TYPE OF ACTION:
Change Plans

GOODNIGHT '35' FEDERAL #1
SEC. 35 - T 23 S - R 29 E
EDDY COUNTY, NEW MEXICO

PROPOSED WELLBORE SCHEMATIC

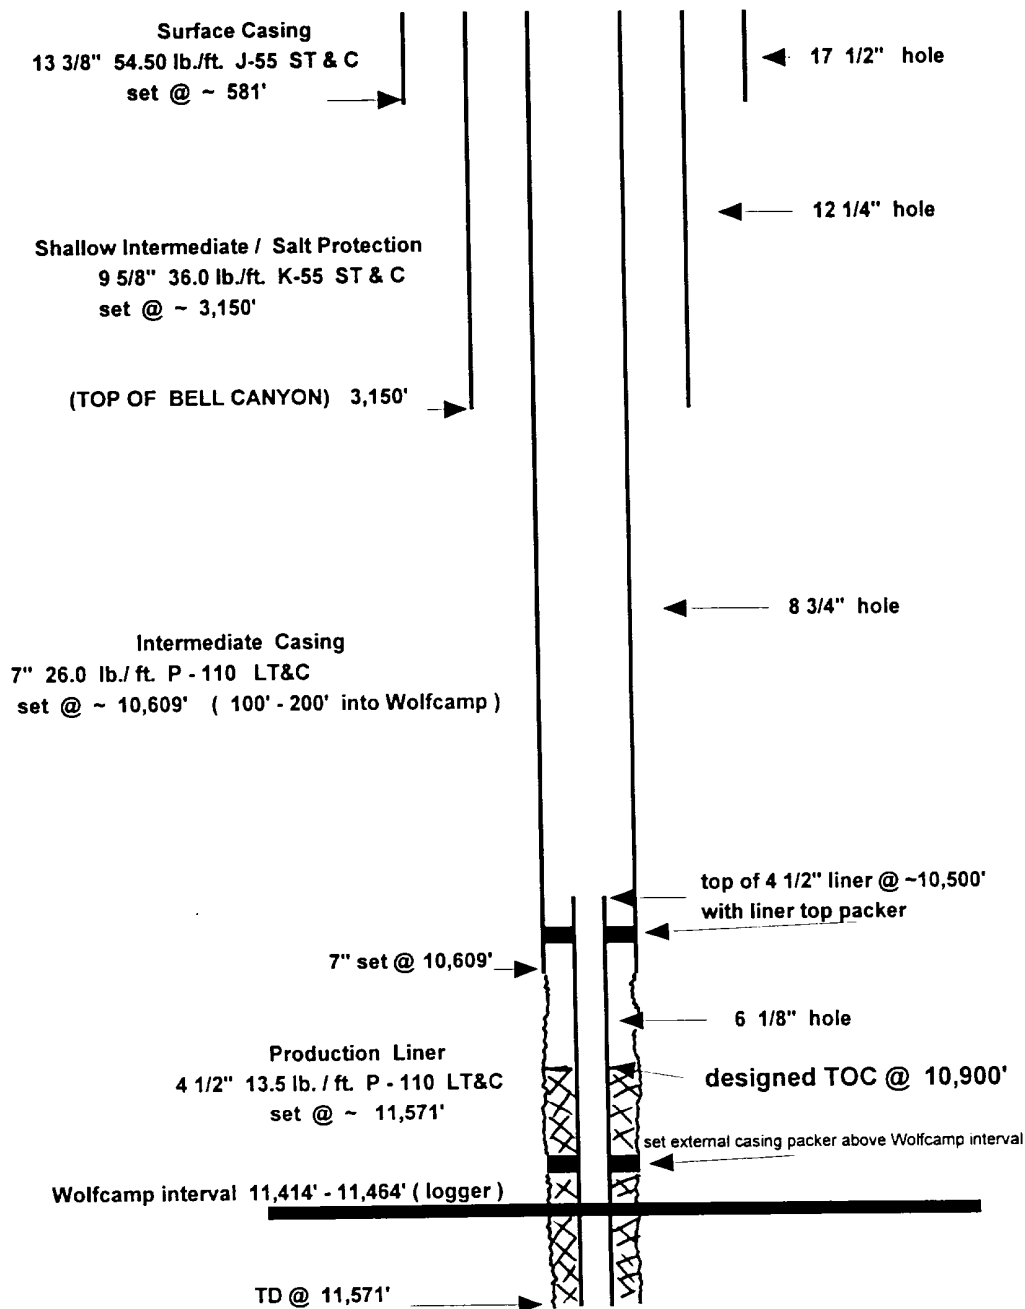
6-15-00 Requested BLM/NMOCD approval to set 4 1/2" liner from present TD @ 11,571' (WLM) as per attached wellbore schematic. Original well plans/permit are for Morrow test. Due to overpressured Wolfcamp interval operator changed plans to complete well in Wolfcamp and deplete to normal pressures. Plans are to re-enter at later depth and sidetrack to permitted depth. Granted verbal approval by BLM and OCD same day.
